**TOWN OF HERNDON, VIRGINIA
HERITAGE PRESERVATION REVIEW BOARD
WORK SESSION AGENDA
MARCH 6, 2019
HERNDON COUNCIL CHAMBERS BUILDING
765 LYNN STREET
7:00 P.M.**

Heritage Preservation Review Board

APPLICATION FOR A CERTIFICATE OF APPROPRIATENESS OF AN AMENDMENT TO AN APPROVED APPLICATION, HPRB #19-02.

An application to consider a Certificate of Appropriateness approving design revisions to the approved alterations, previously authorized through HPRB #17-15, to the commercial structure located at 765 / 767 Elden Street, Herndon (Attachment #1).

WEST ELEVATION

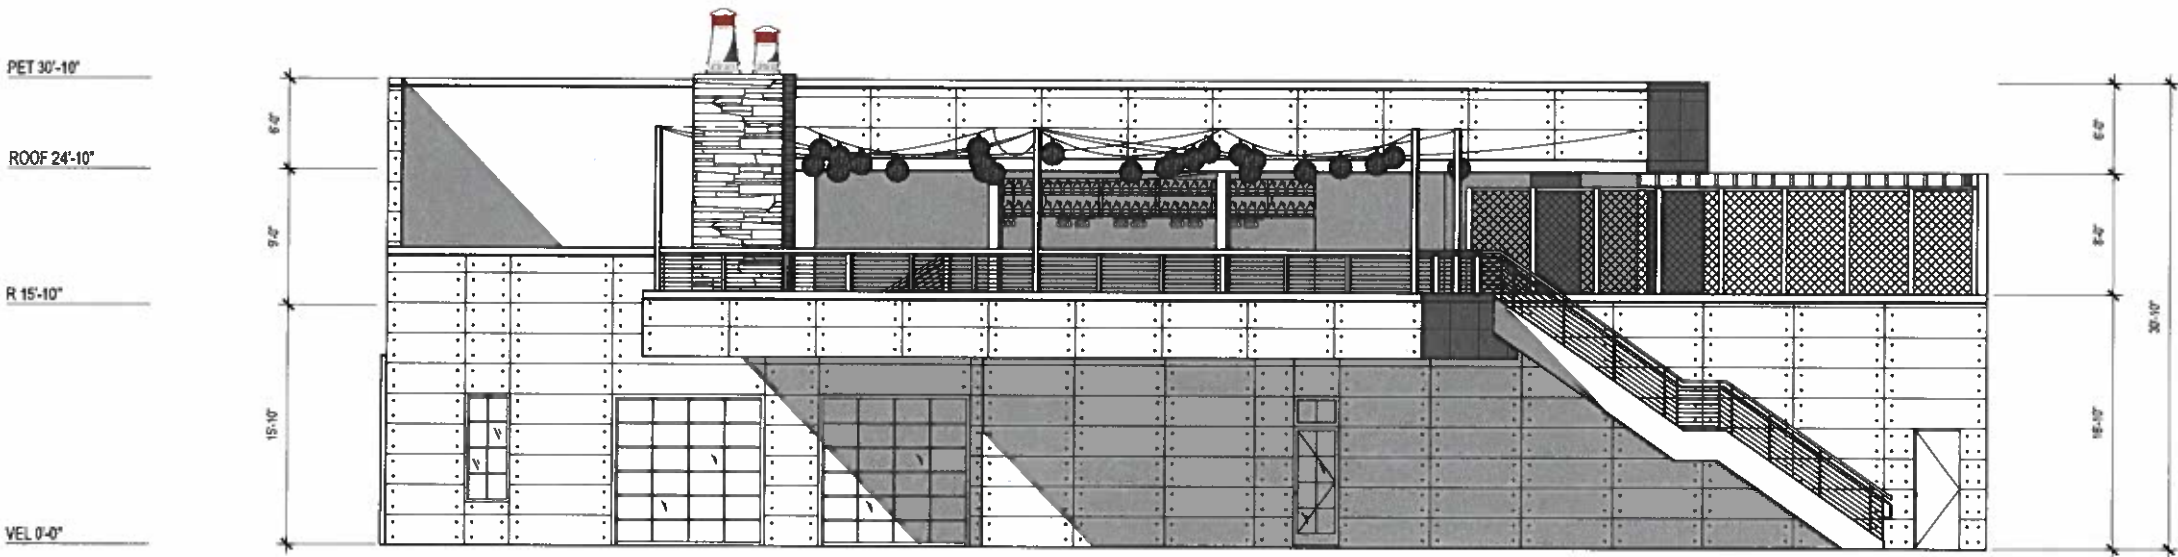
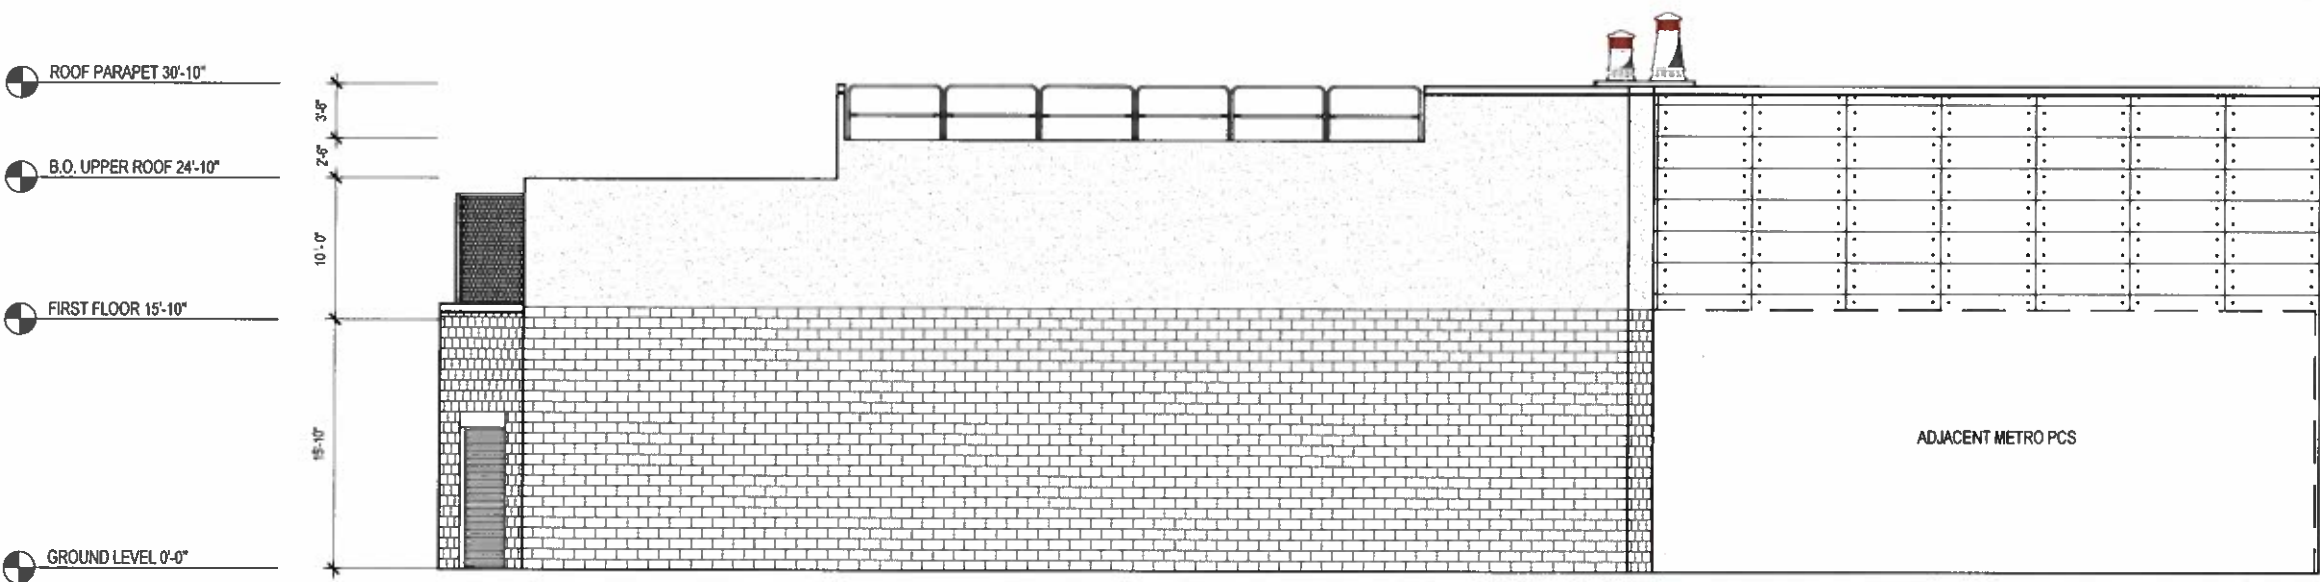
- a. Identification and detailed information related to the new walled stairwell enclosure
 - b. Clarification and explanation of the removal of the black wire mesh from the second floor of the west and south elevations

A401

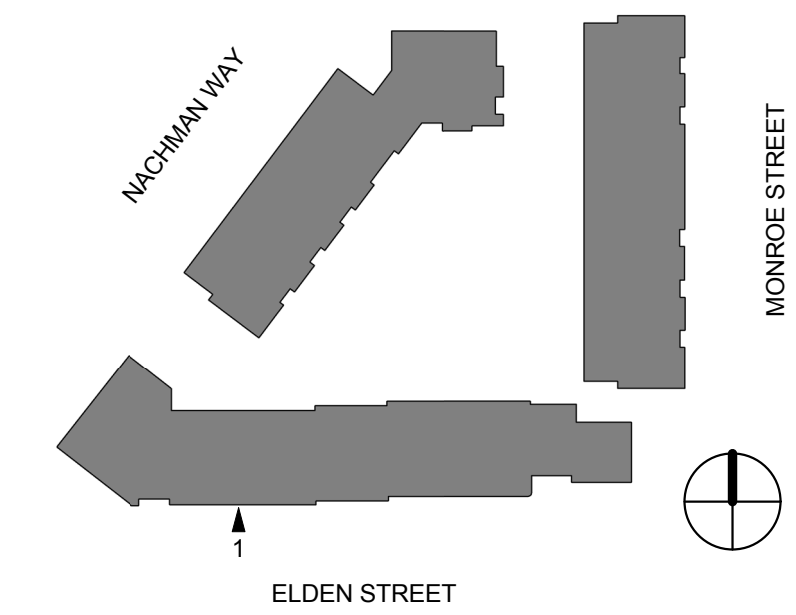
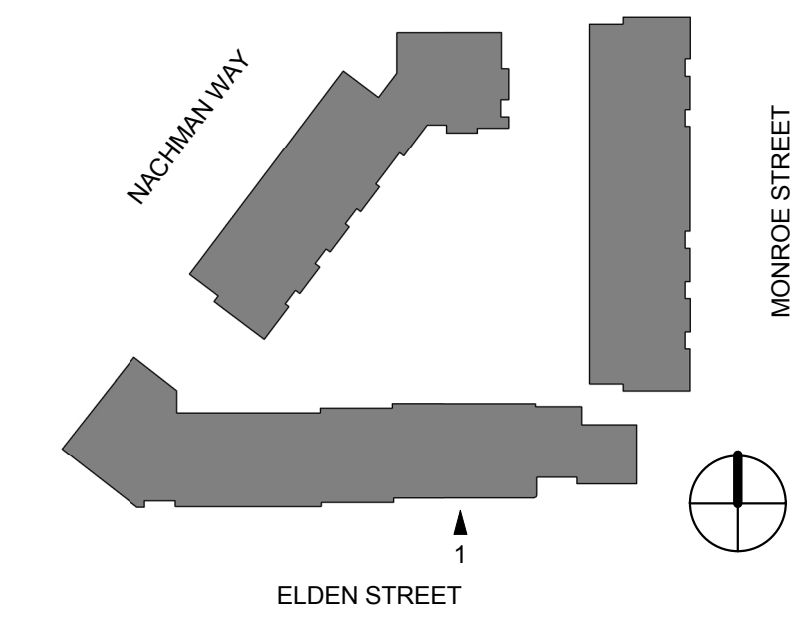
- 4) The base at the storefront of the 708A & 710A Elden Street commercial units does not match the approved HPRB drawing set (Sheet A401, Attachment #4). The depth of the base appears substantially deeper than the approved elevations.

- 5) Louvers have been added above the storefront windows at the 702A & 704A Elden Street commercial units in place of a split brown Hardie-panel® above the storefront windows (Sheet A401, Attachment #4).

1. The design modifications remain in substantial conformance with the application and supporting materials submitted February 8, 2019 and previously approved by this board with HPRB #15-20.
